Access Compliance Report

Public Rights-of-Way

(Curb Ramps)

Intersection ID: 5832	Main Street: N_TRYON_ST	Cross Street: KEN_HOFFMAN_DR	Location:	N
ADA ID: F91F218611F1	Ramp Type: Combination2	Initial Pass/Fail: Fail	Overall Compliance: No	Severity Score: 12.5

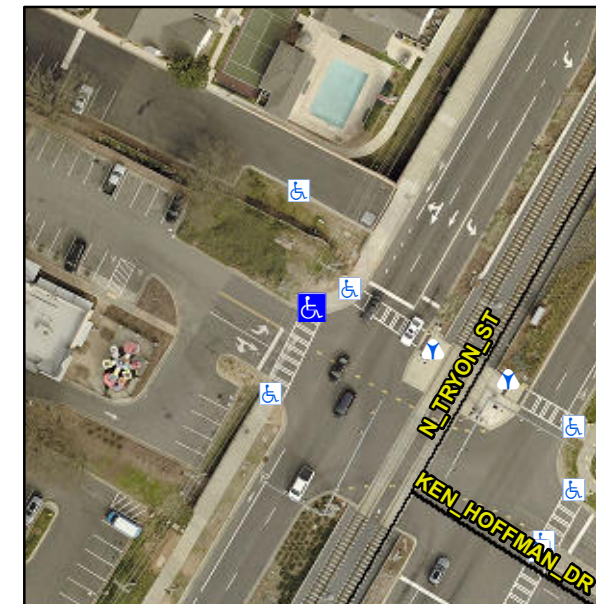
R304.5.1, R304.3.2

Remove & Replace Entire Ramp.
